March 20, 2018  
15045

**Third Party Review of the Rezoning Petition in Northern Aroostook County, Fish River Chain of Lakes Concept Plan**

### SLOPE EVALUATION OF FISH RIVER CHAIN OF LAKES DEVELOPMENT AREAS

SLOPE EVALUATION  
 OF: FISH RIVER CHAIN OF LAKES DEVELOPMENT AREAS  
 FOR: J.D. IRVING LIMITED

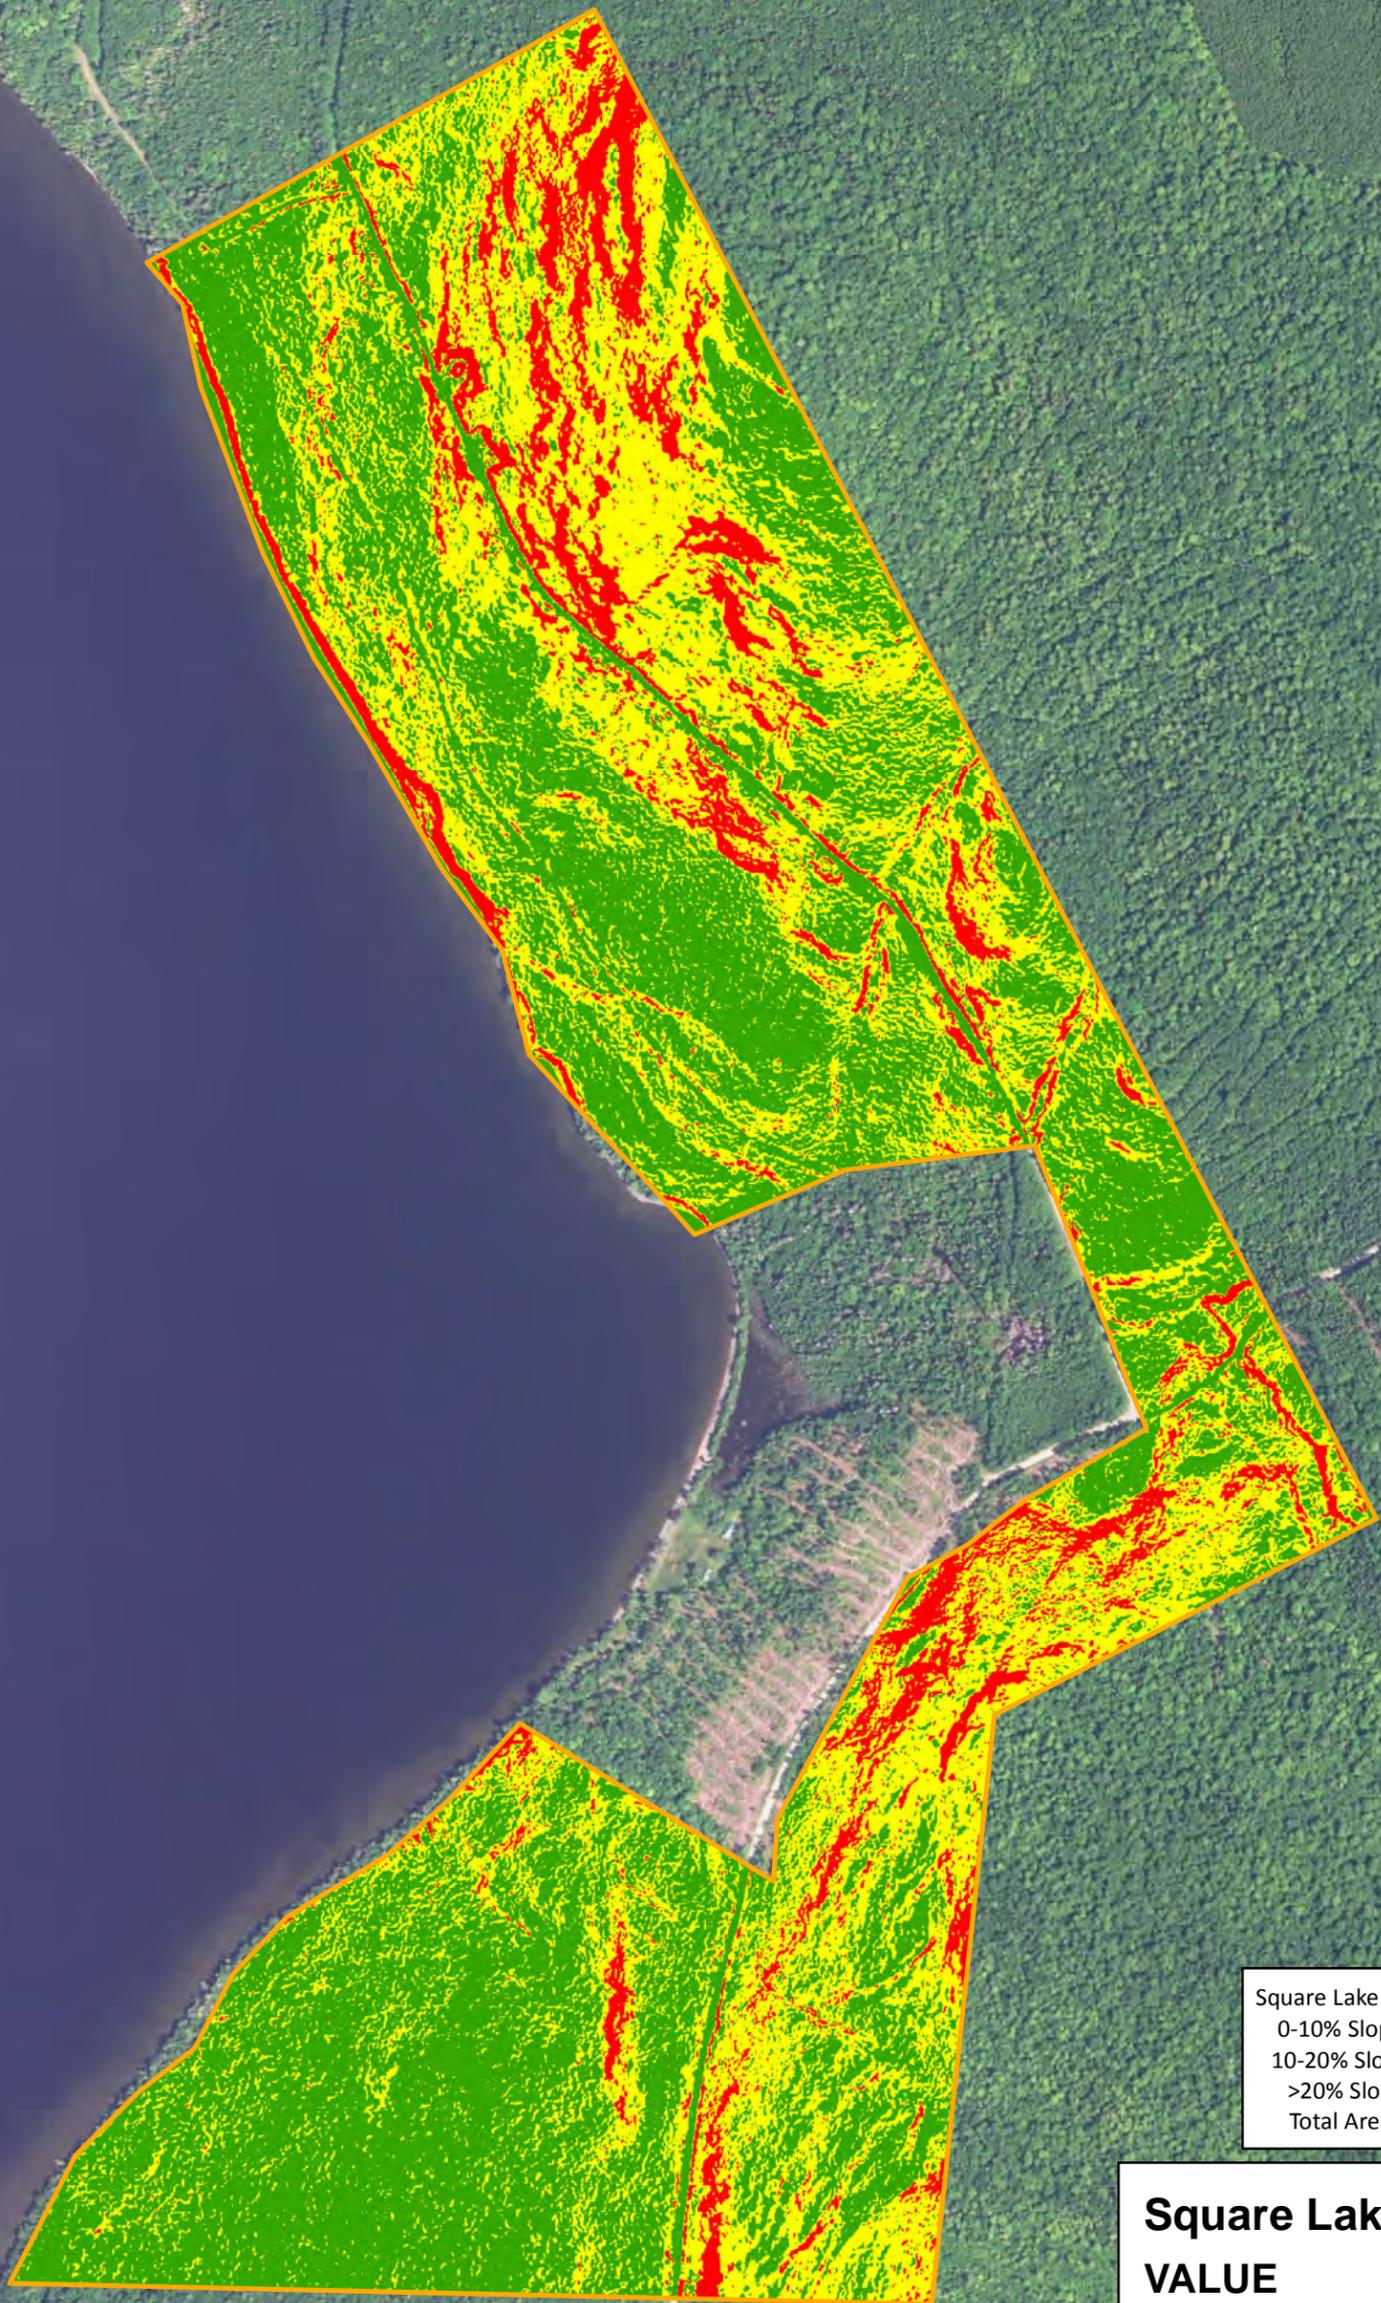
1. **Slope Analysis:** The slope analysis indicates approximately 47 acres of the development area contain slopes greater than 20 percent and generally considered unsuitable for development. The greater than 20% slopes appreciable and likely associated liner slope features. Slopes 0-10% slopes encompass approximately 28 acres. Limited suitability slopes (10 to 20% slopes) encompass approximately 41 acres of the project area. The slope assessment suggests the development area is suitable for the intended purposes noting that extensive slopes greater than 20% that are not considered suitable for development due to limitations for wastewater disposal systems, erosion and drainage control considerations and slope stability. These areas are will restrict the locations for development, access and require careful planning to accommodate the slopes.

2. The soils in this development area (NRCS Mapping) include HcV (Howland silt-loam), ThC (Thorndike channery silt loam) and PgB/PgC/PgD (Plaisted gravelly loam) soil series. A small area of MoB is located in the westerly corner of the site. These soils range from a gravelly loam to a silt-loam and are well, moderately somewhat excessively drained with a water table over 17 inches and considered a hydrologic group "C" and "C/D" soils. The ThC soils are generally shallow to bedrock which serves as a restrictive layer at 11 to 23 inches. Theses soils present some limitations depending on slope and location of the restrictive layer along with higher erosion potential for the surficial soils and potential difficulties addressing stormwater management.

Considering the soil types and associated development limitations including slopes over 20%, our assessment suggests that the project area and number of planned units (25) yields an effective net density of 2.0 acres/unit. This represents a reasonable and appropriate net development density (Please refer to the development matrix analysis appended to this report) noting that the steep slopes will restrict development from several areas of the project area. This assessment includes deductions for slopes over 20% and allowing for 25% of the 10% to 20% (limited suitability slopes) to be considered not suitable.

LOCATION: SQUARE LAKE E	FOR: J.D. IRVING LIMITED	INFORMATION: 2011 LIDAR DERIVED DATA PROVIDED BY J.D. IRVING, LIMITED	SCALE: 1" = 600'
			DATE: 03/07/18

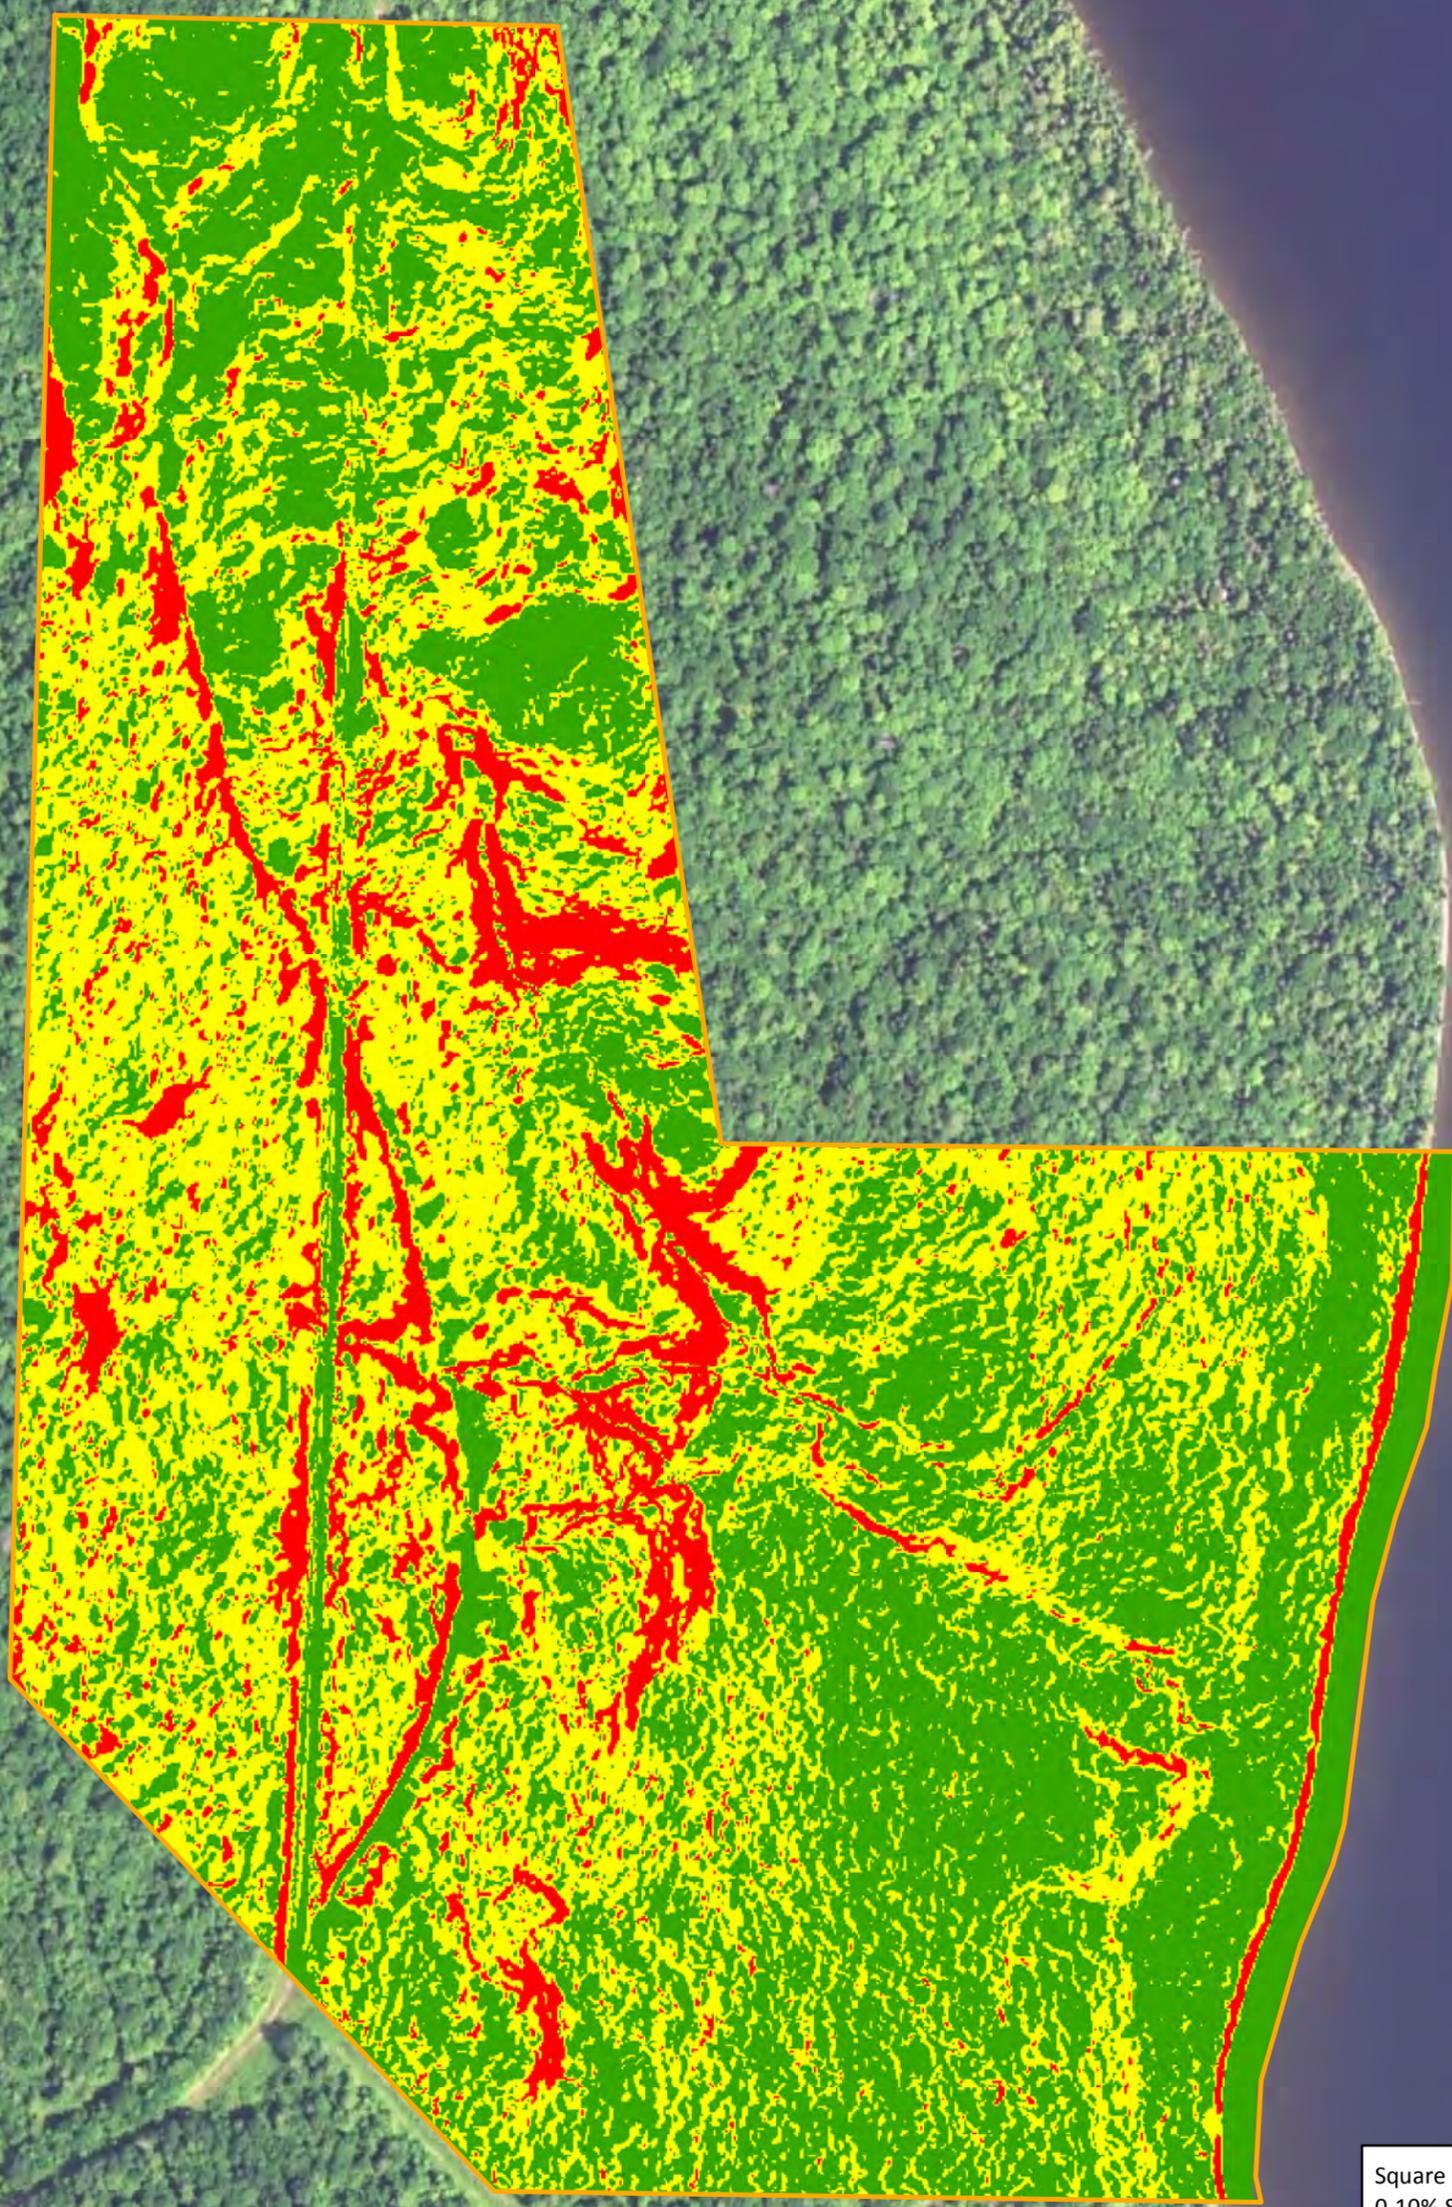
1. Slope Analysis: The slope analysis indicates approximately 31 acres of the development area contain slopes greater than 20 percent and generally considered unsuitable for development. The greater than 20% slopes are generally associated with linear features most likely contiguous slopes on hillsides. The area adjacent to Square Lake generally contains a shoreline section of slopes greater than 20% restricting the development in this area. Slopes 0-10% slopes encompass approximately 138 acres. Limited suitability slopes (10 to 20% slopes) encompass approximately 112 acres of the project area. The slope assessment suggests the development area is suitable for the intended purposes noting that the slopes greater than 20% are not considered suitable for development due to limitations for wastewater disposal systems, erosion and drainage control considerations and slope stability. Provided the development planning avoids the steeper slopes and recognizes the partial limitations of the 10% -20% slopes, adequate land area exists to accommodate the 85-unit density.

2. The soils in this development area (NRCS Mapping) include PgC (Plaisted gravelly loam), HoC (Howland gravelly loam), PvC (Plasited Howland association), HcV (Howland silt-loam) soil series. These soils range from a gravelly loam to a silt-loam and are moderately well drained to well drained soils with a water table over 16 inches and considered a hydrologic group "C" and "C/D" soils. These soil types do not suggest impractical limitations for development beyond localized limitations as a result of steep slopes (over 20%) and a higher-grade soil mapping. We would note that the HcV soils are considered a finer soil and may be more susceptible to erosion when disturbed but are generally suitable for development. Wetlands areas were also identified on the project site and generally located along the Square Lake Yexas and Square Lake E property division line and near the southerly end of the Square Lake E development area. The Wetlands are considered not suitable for development.

Considering the soils, streams, wetlands and associated development limitations, slopes over 20% and the development setback restrictions along the shoreline of Square Lake, our assessment suggests that the project area and number of planned units (85) yields an effective net density of 2.2 acres/unit. This represents a reasonable and appropriate net development density (Please refer to the development matrix analysis appended to this report). This assessment includes deductions for slopes over 20% and allowing for 25% of the 10% to 20% (limited suitability slopes) to be considered not suitable.

LOCATION: SQUARE LAKE W	FOR: J.D. IRVING LIMITED	INFORMATION: 2011 LIDAR DERIVED DATA PROVIDED BY J.D. IRVING, LIMITED
----------------------------	-----------------------------	--

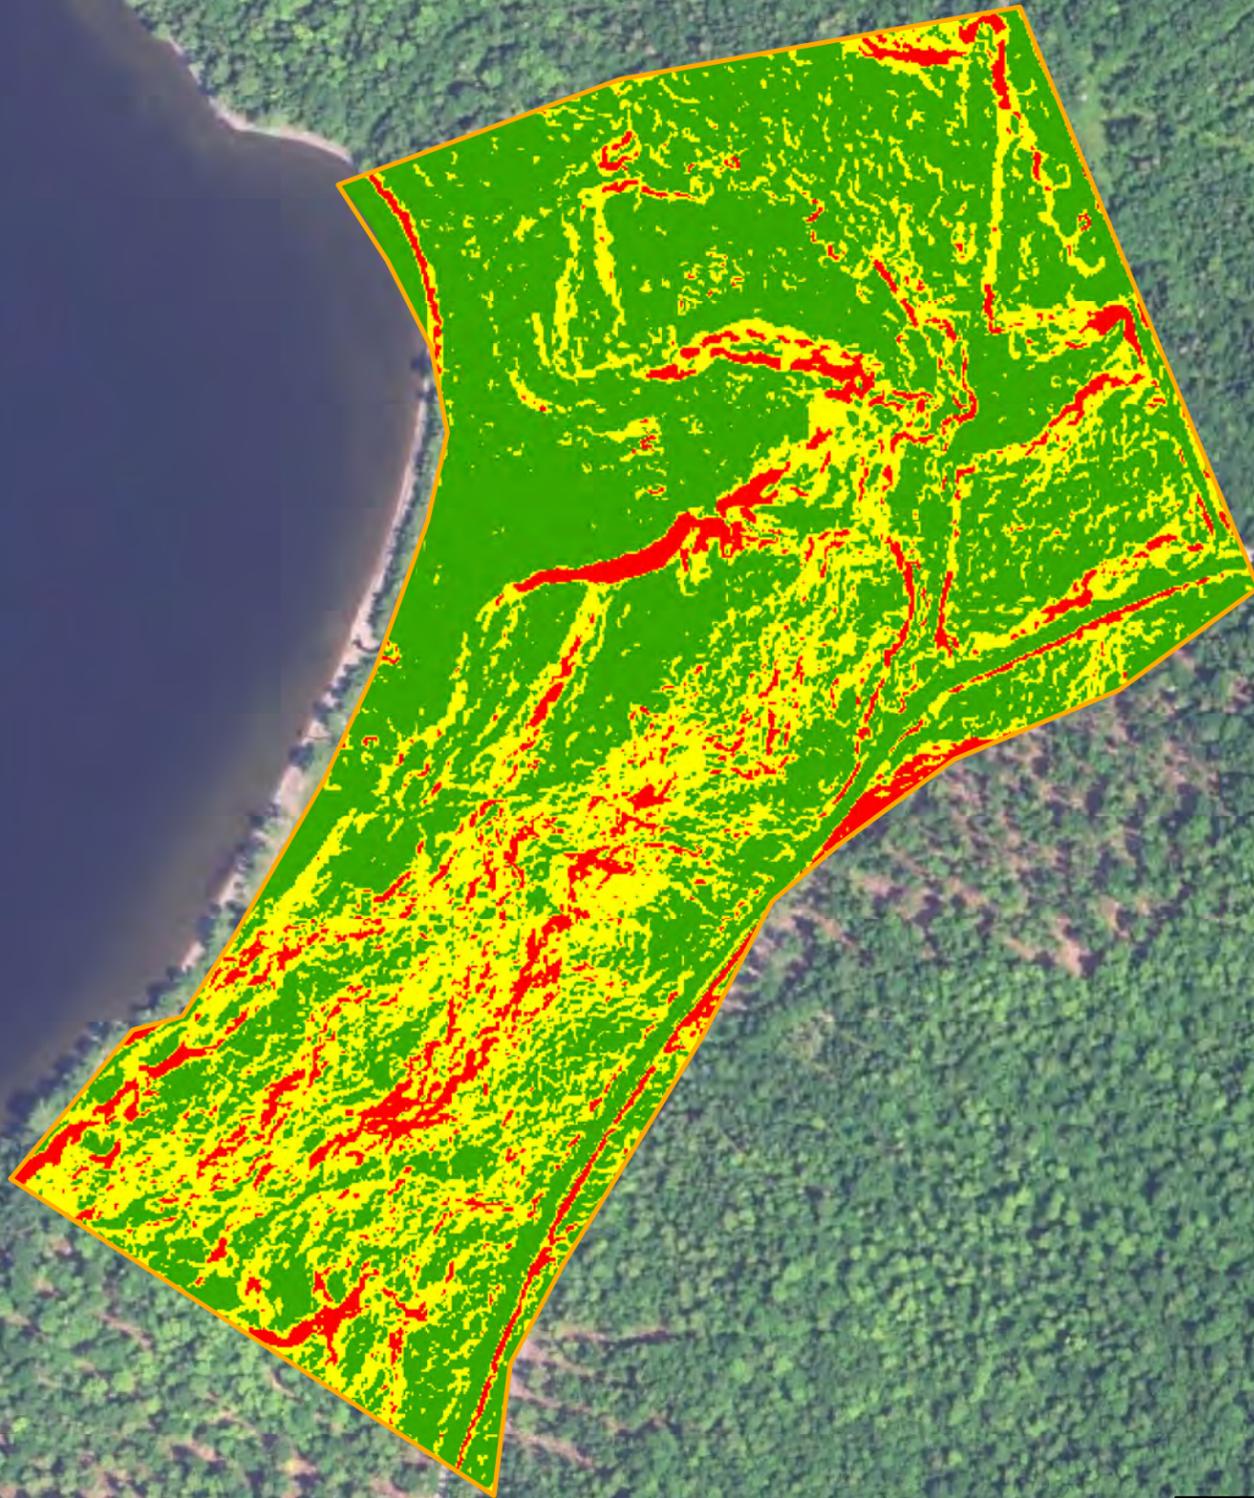
1. **Slope Analysis:** The slope analysis indicates approximately 13 acres of the development area contains slopes greater than 20 percent that are considered unsuitable for development. The greater than 20% slopes are generally scattered throughout the westerly area of the development parcel with some continuous linear slope features. The area adjacent to Square Lake generally contains 0-10% slopes interspersed with limited development areas of 10 to 20% slopes. The slope assessments suggest the development area is suitable for the intended purposes noting that the few areas of slopes greater than 20% which are not considered suitable for development due to limitations for wastewater disposal systems, erosion and drainage control considerations and slope stability. Provided the areas of 20% slope features are avoided, the slope conditions are expected to be suitable for the intended use.

2. The soils in this development area (NRCS Mapping) include PvC (Plaisted Howland), HvB (Howland) and ThD (Thorndike channery silt loam) soil series. The ThD soils are considered unsuitable due to steep slopes, shallow to bedrock and expected susceptibility to erosion when disturbed. We would note that the soils mapping and the LIDAR data depict differences in the steep slope areas since the NRCS data is not based upon the more accurate LIDAR Data. As a result, we anticipate the areas of unsuitable soils due to steep grades will be dispersed throughout the development area as shown on the enclosed LIDAR mapping which consumes approximately 13 acres of the development area. Any development activities within the project area will need to be based upon actual field mapping of the slopes and soils to accurately integrate the physical slope restrictions in to the development. The PvC and HvB soils are both generally stony soils and located on slopes 8% to 15%. These soils are generally well drained with a water table over 2 feet and considered a hydrologic group "C/D" soil.

Considering the soil classifications, slopes and limitations for development along the shoreline of Square Lake, our assessment suggests that the project area and number of planned units (30) yields an effective net density of 2.7 acres/unit suggesting the proposed density and development area is reasonable and appropriate (Please refer to the development matrix analysis appended to this report). This assessment includes deductions for slopes over 20% and allowing for 25% of the 10% to 20% (limited suitability slopes) to be considered not suitable.
